Indoor Station Firmware Release Note (2024-11-01)

Device Model	DS-KH8350-WTE1, DS-KH8350-TE1, DS-KH6320-WTE1, DS-KH6320-TE1, DS-KH6320Y-WTE2, DS-KH6320EY-WTE2, DS-KH8520-WTE1, DS-KH6320-WTDE1, DS-KH6320-TDE1
Firmware Version	V2.2.96_build241028

Indoor Station Firmware V2.2.92_build241008 Release Note (2024-10-25)

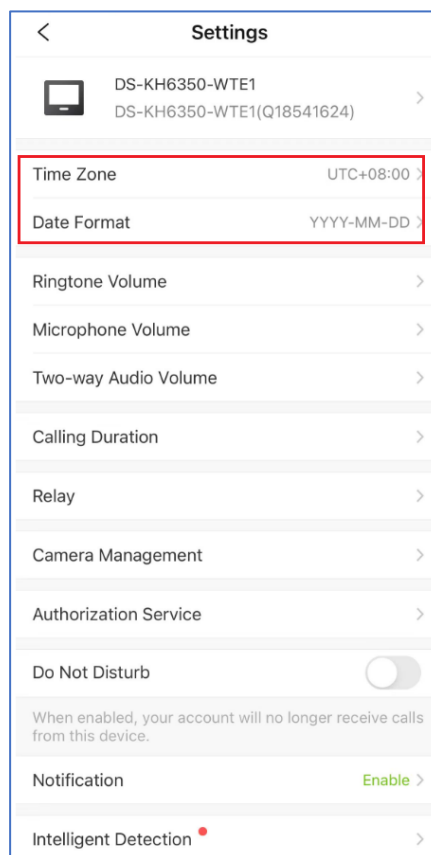
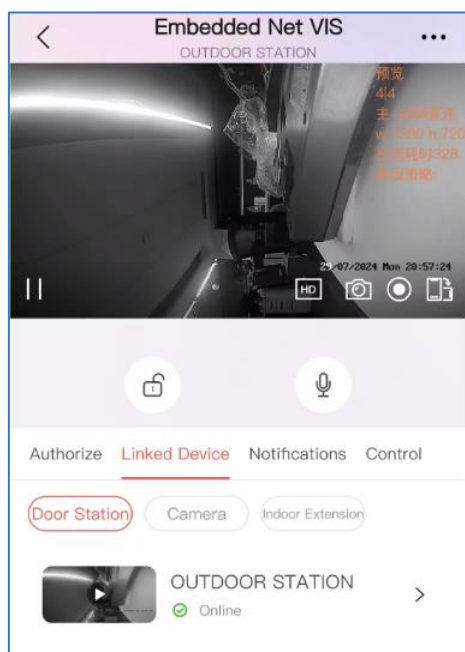
1. Optimize the audio quality with NetEQ algorithm and add 16KHz sampling rate (only support 8KHz before), supports more audio formats (auto-negotiation), including G.711u, G.711a, G.722.1
2. Support switching between main and sub stream (HD and Basic) when live view the door station

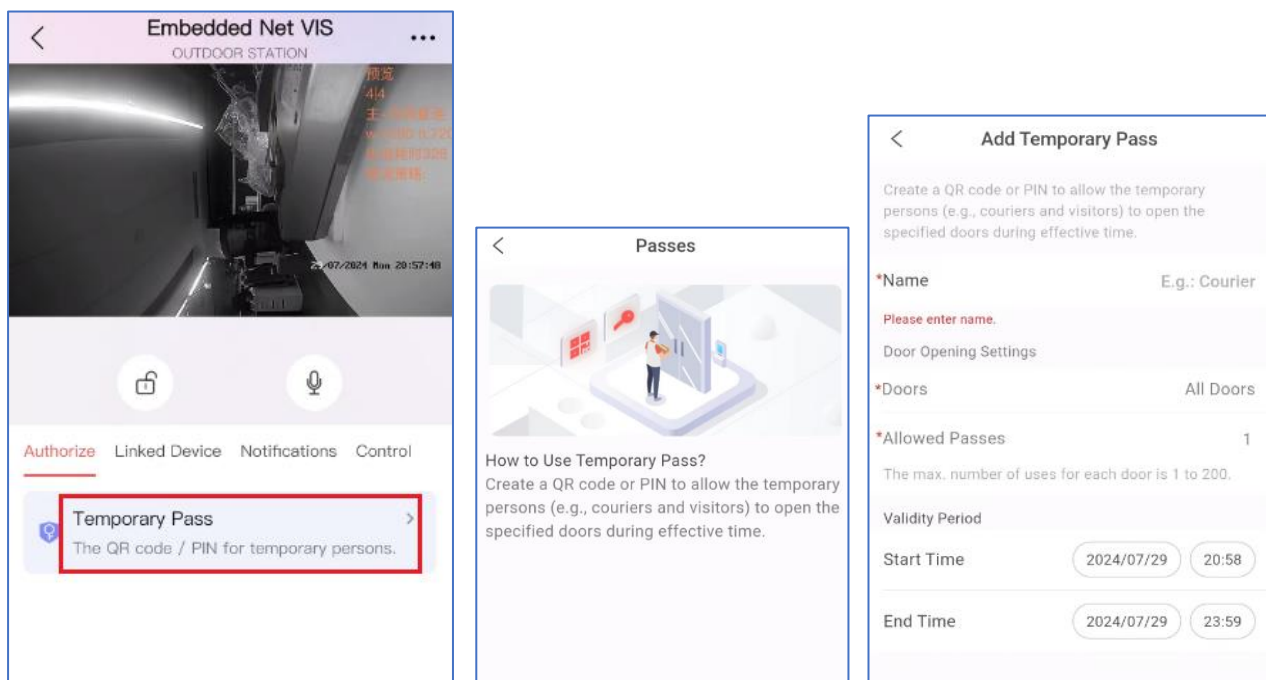
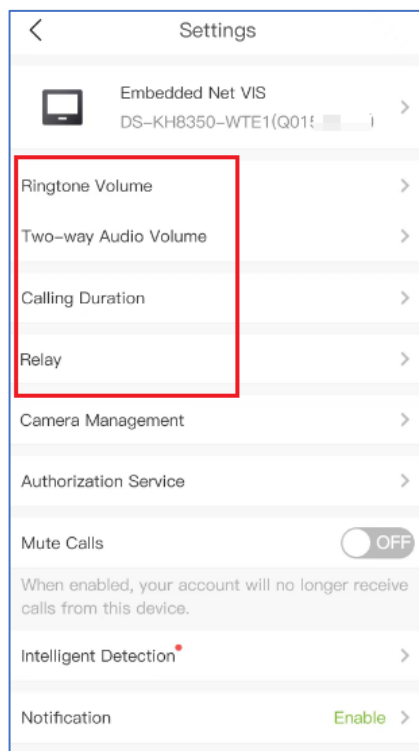
- Support adding temporary visitor QR and PIN on Hik-Connect and apply to the door station.

Note: This function should be supported by the door station at the same time.

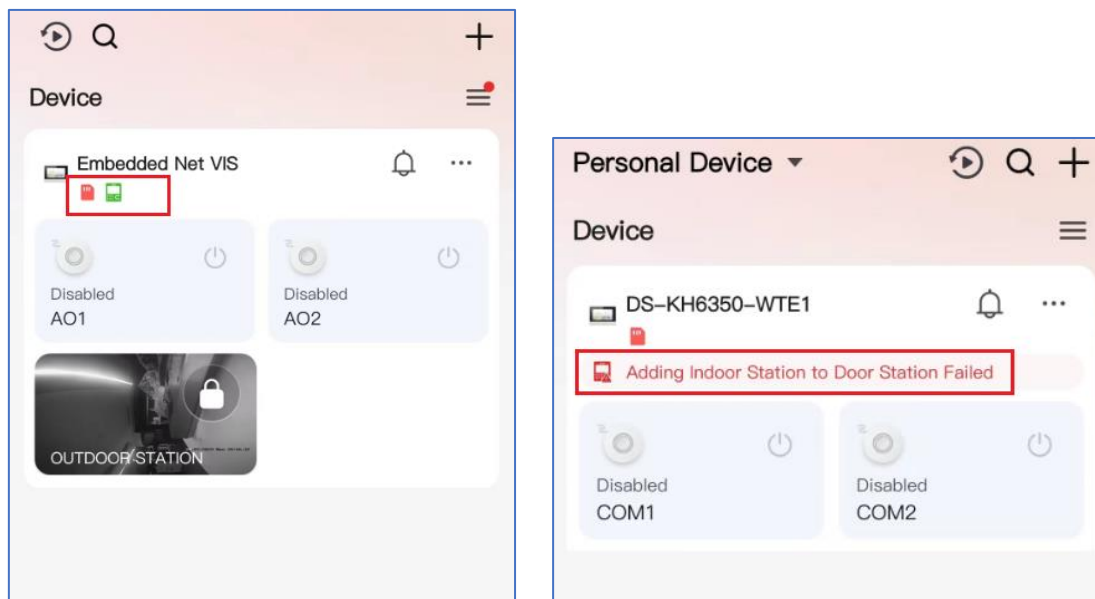
- Configure the ringtone/intercom audio volume, call duration and TF card parameters from Hik-Connect

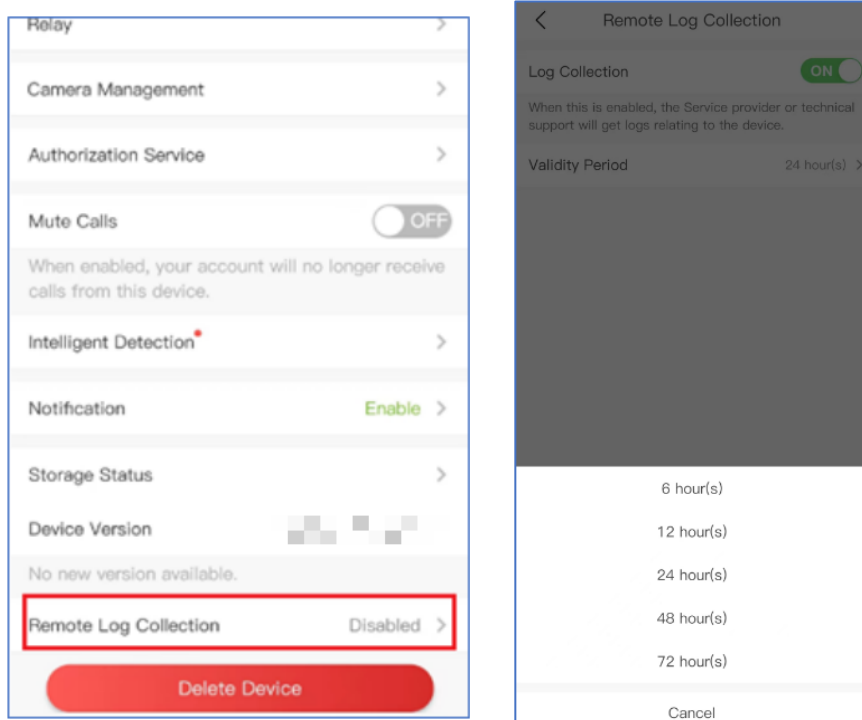
8. Support collecting the device log from Hik-Connect cloud after the end user enable the authorization service from App, within the valid duration, technical support can collect the device log.

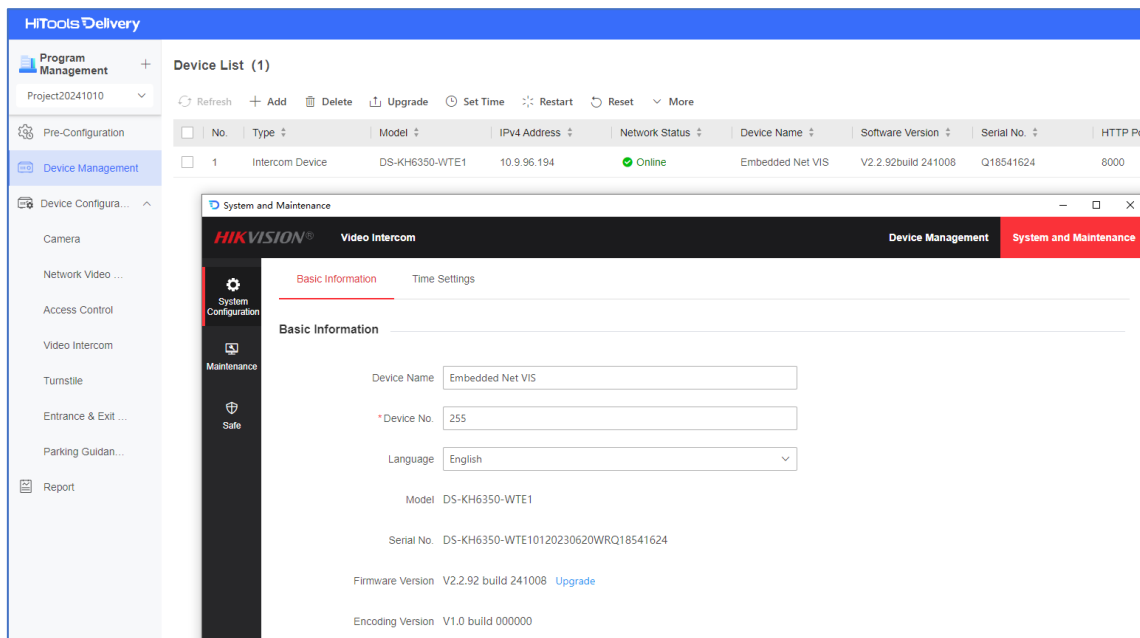
- Compatible with HiTools Delivery, and open remote configuration menu to make some settings.

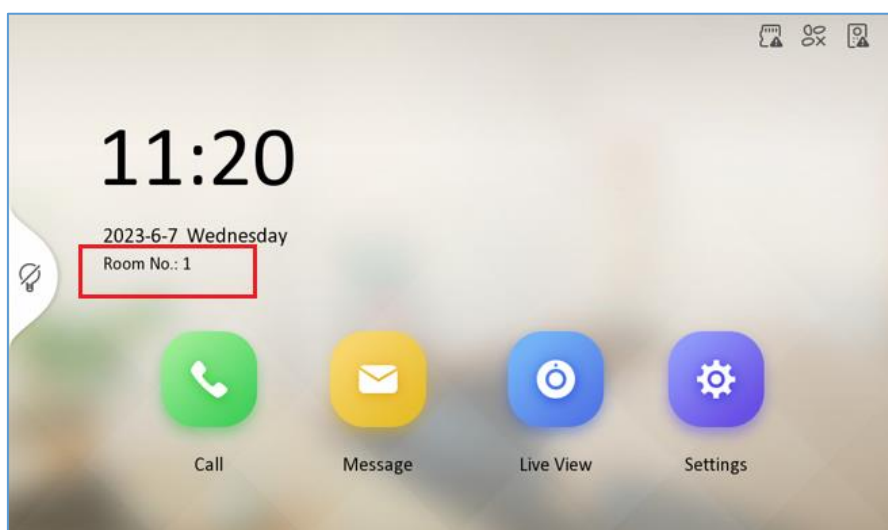
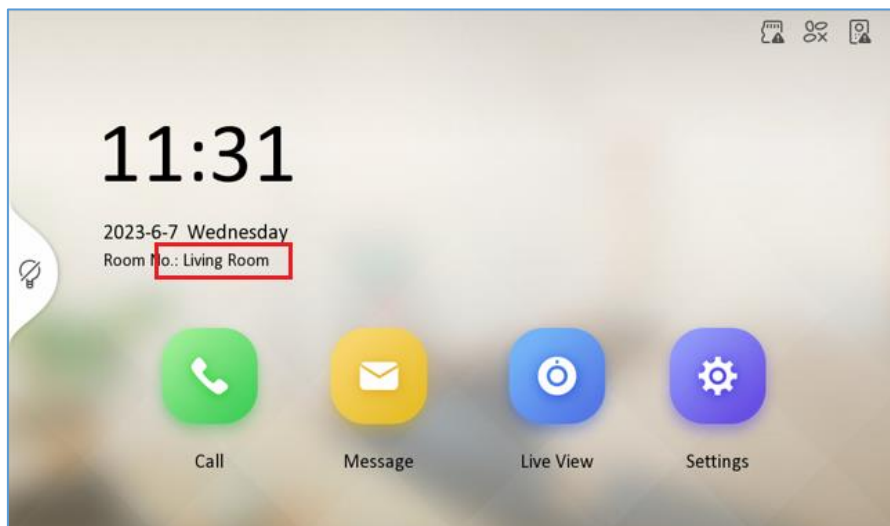
- support self-defined indoor station name on the screen, there are 3 option, display room No., Room name or do not display, by default it's room No.

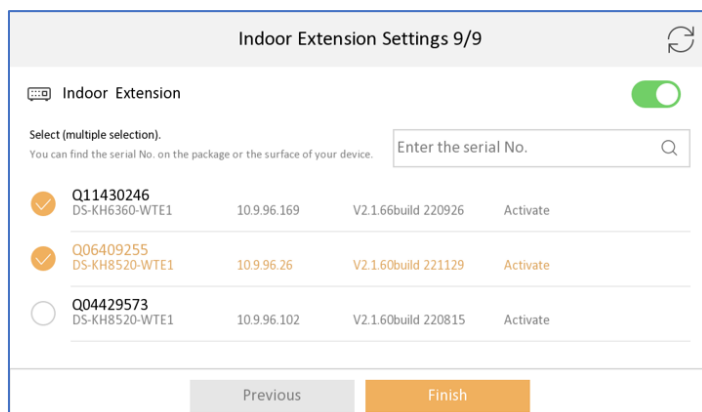
B. Link indoor station with main and sub door station

- the first selected will be the main door station by default, the second will be sub1, 3rd will be sub2, etc. You can also cancel and select the main door station manually.
- Maximum select 17 door stations at one time (1 main and 16 sub door stations)
- If the selected devices are not activated, indoor station will activate them with same activation and registration password, then set the IP address for them in same network segment automatically.
- If the door station is already activated with different password, it will prompt you to input door station password
- If the main and sub door station are activated with different activation password, the registration will be failed (sub door station can't call indoor station).

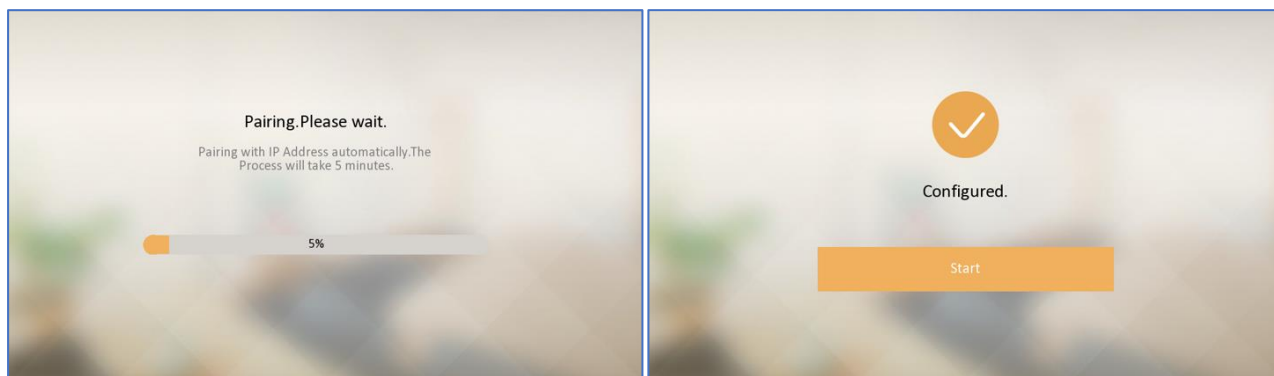
D. Pairing with main door station, sub door station and indoor extension

Note: The pairing time duration depends on the device quantity you selected in previous steps, it will take about up to 5 mins, please wait patiently until the process finish and show “Configured” as below.

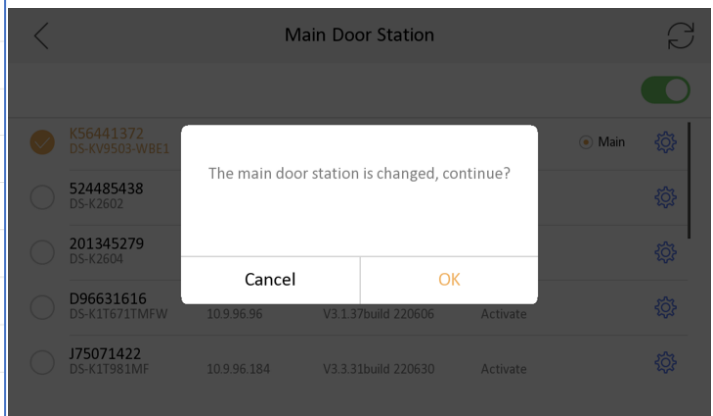
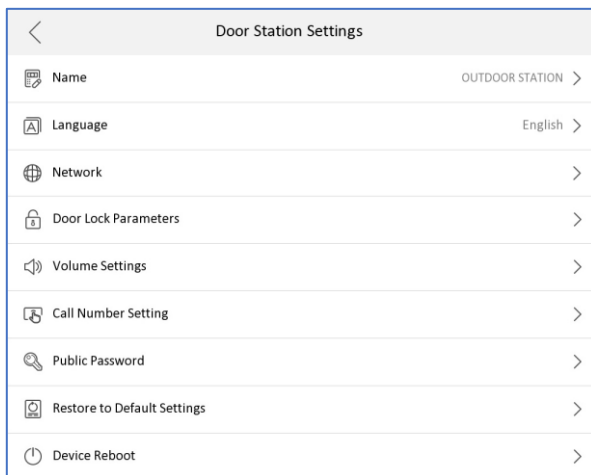
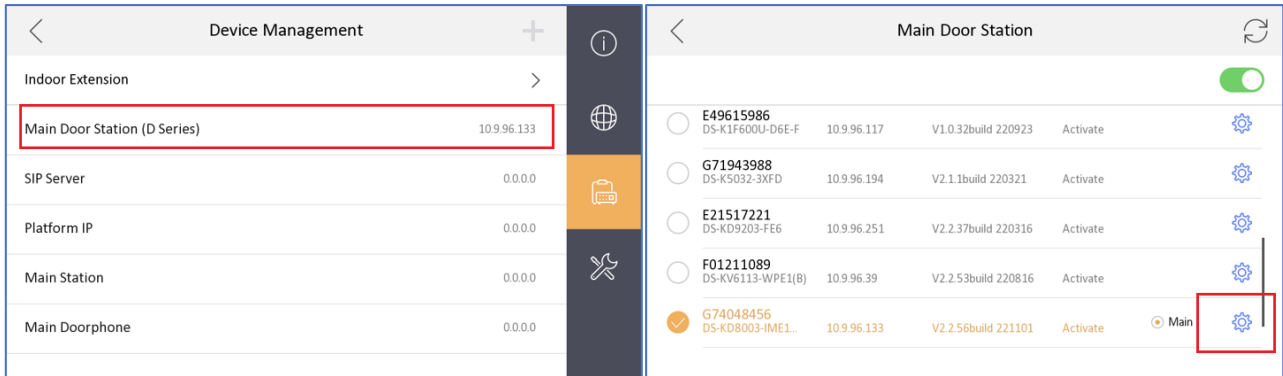
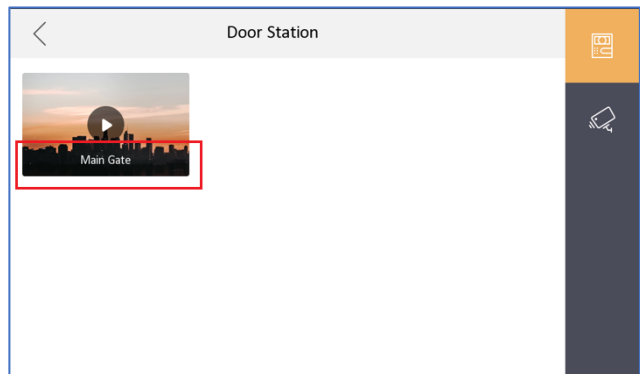
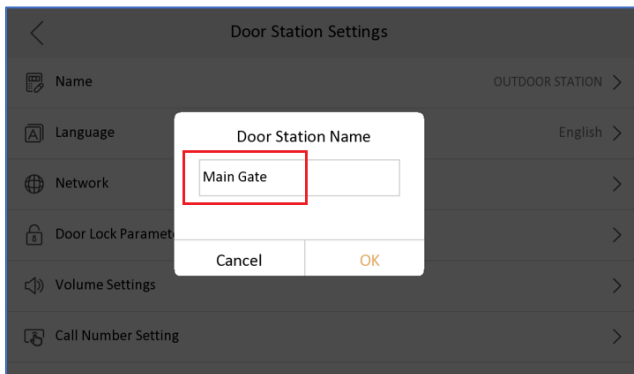
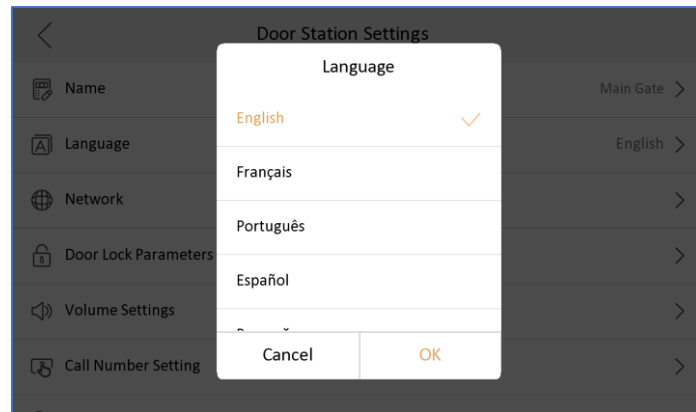
11. Set the important parameters of door station from indoor station Menu-Advanced settings-Configuration-Device Management-Main Door Station (not from the wizard).

- You can change parameters of all door station (no matter it's linked or not) in the list by click the setting icon, see pic 2.
- You can also change linked main door station from this list by click device from the list, if you want to change linked sub door station, please go to Advanced settings-Configuration-System maintenance-Wizard, and link device again.
- After change the linked main door station, device will prompt “The main door station is changed, continue?”, see pic4 as below

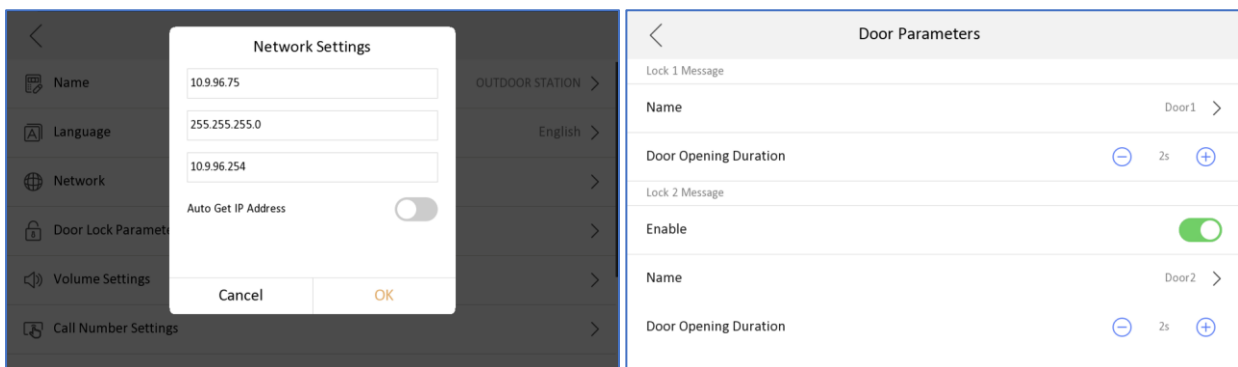
A. Set door station name (will be displayed in live view page), set door station language.

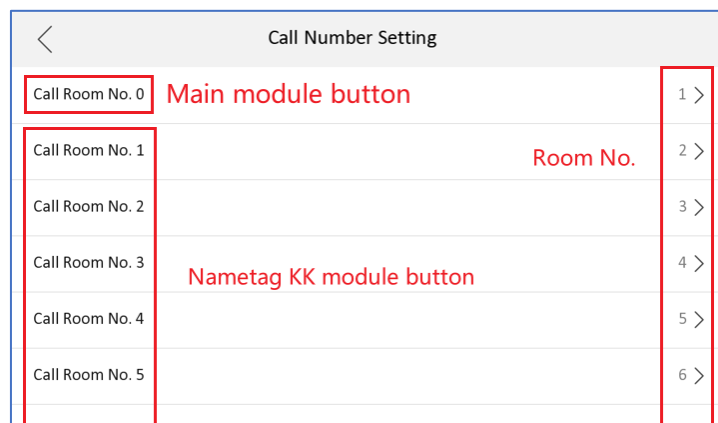
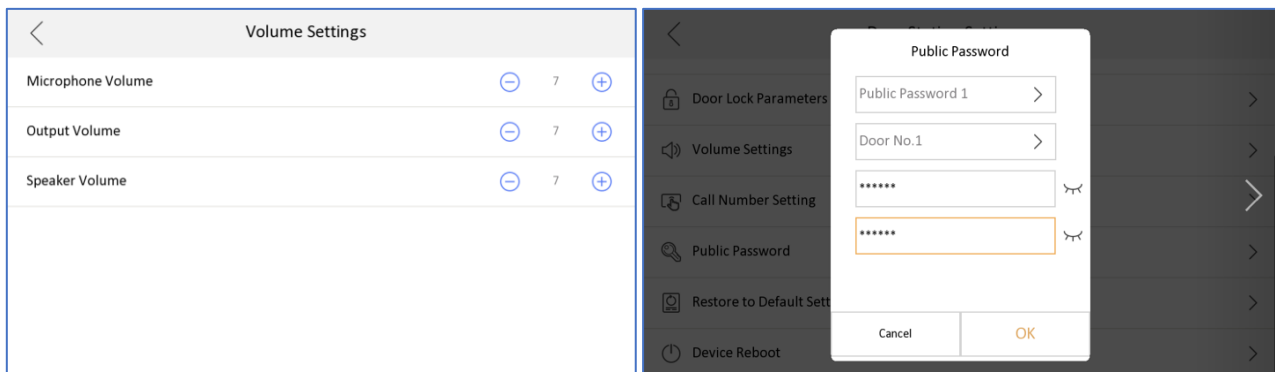
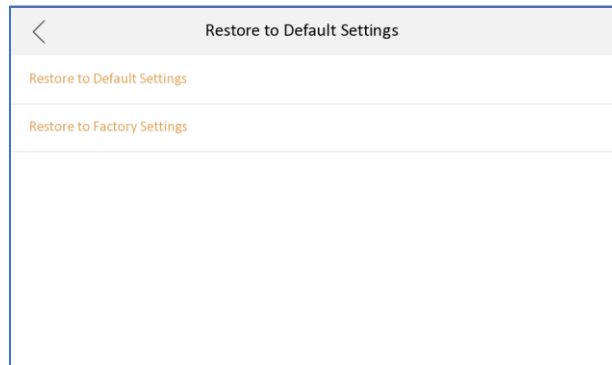
B. Set door station IP address, subnet mask, gateway, enable DHCP, lock name, door open duration, enable lock2, etc.

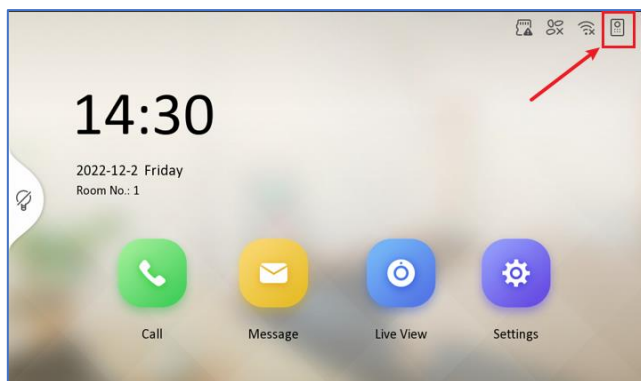
C. Door station volume setting, physical button call number, public password (lock1 or lock2)

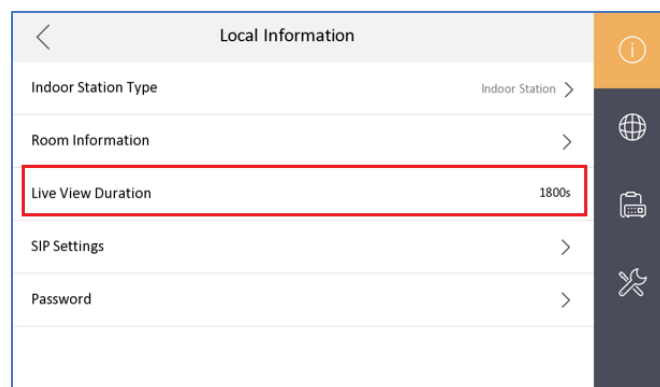
- Optimized the icon of door station registration status in the main UI up right corner.

Note: If the door station call indoor station failed, you can click this icon  to register to door station manually, if register failed, it will indicate the reason for the failure.

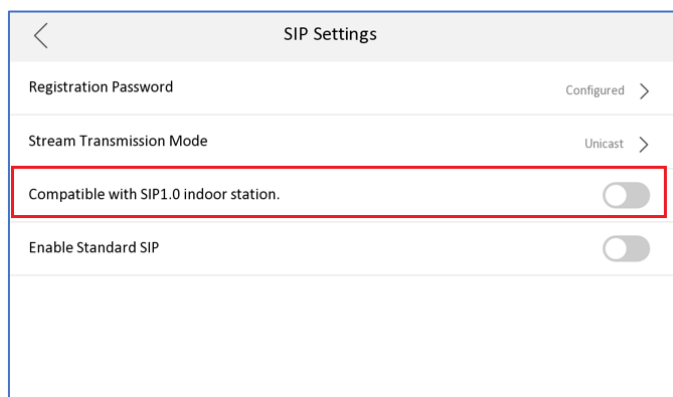
- Support switching between protocol 1.0 and 2.0, by default it's protocol 2.0
After enable, the indoor station is compatible with protocol 1.0 indoor extension and not

Note: After enable, all indoor extension of this indoor station must be protocol 1.0 firmware, don't mix protocol 1.0 and 2.0 indoor extension under same indoor station, or it will result to calling failed.

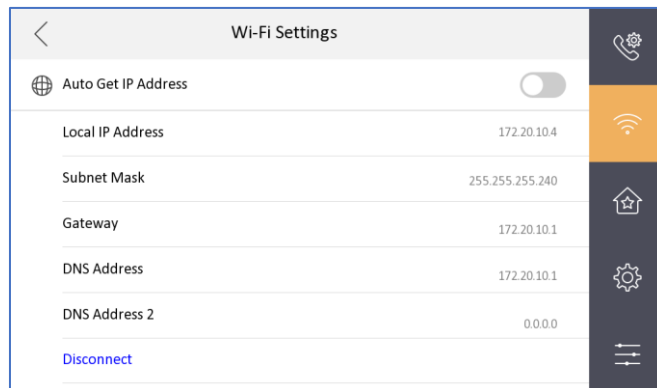
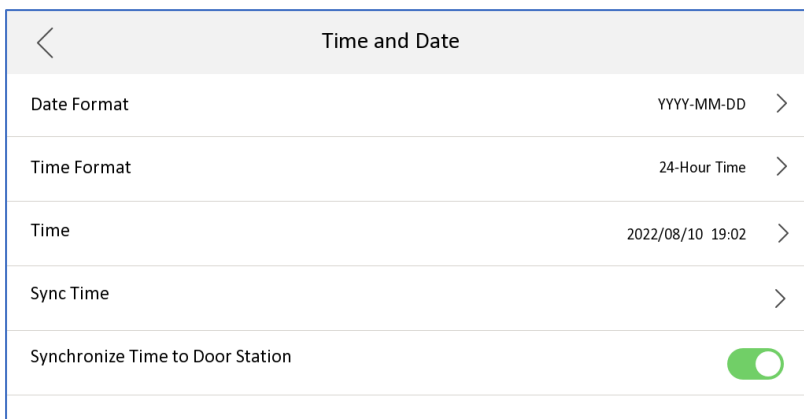
1. Supports static IP address configuration of Wi-Fi (DHCP, IP address, subnet mask, gateway, DNS1, DNS2).
